SERVICE BULLETIN

SRV 09-009

Product: Grain Belt Plus 2009.

Re: Roller arm clamp replacement.

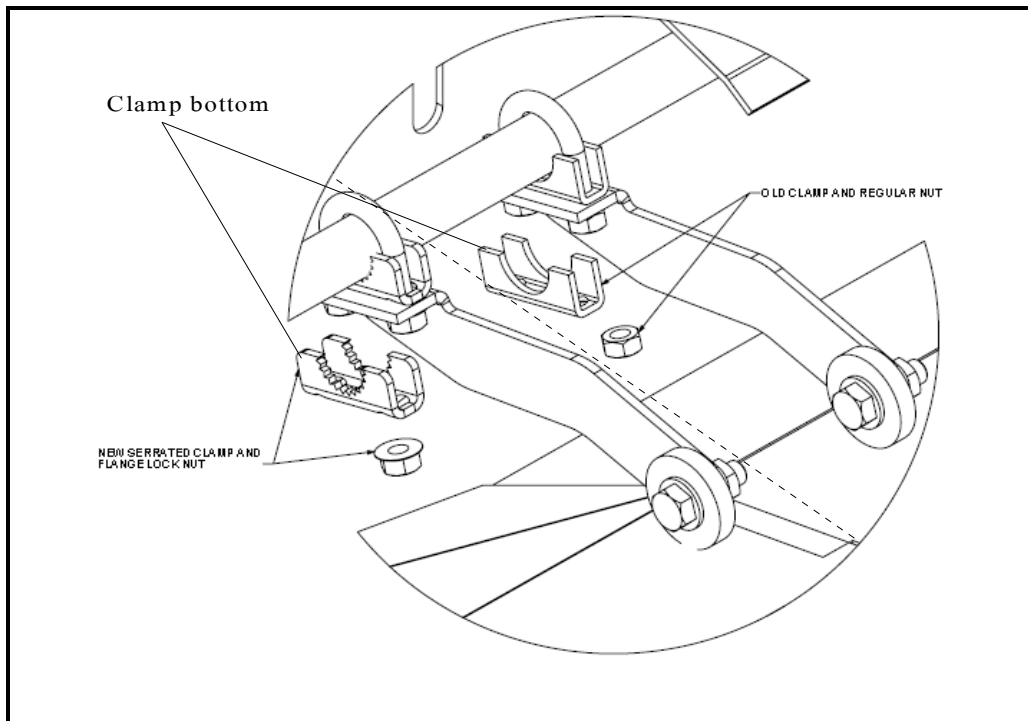
Problem: Cutter bar header height roller arm clamps will not stay tight.

4. Remove and discard existing roller arm U clamp bottom and the UNC retaining nuts.

Solution: Replace U clamp bottom and existing UNC nuts.

5. Replace with serrated U clamp bottom and flange nuts, as shown above.
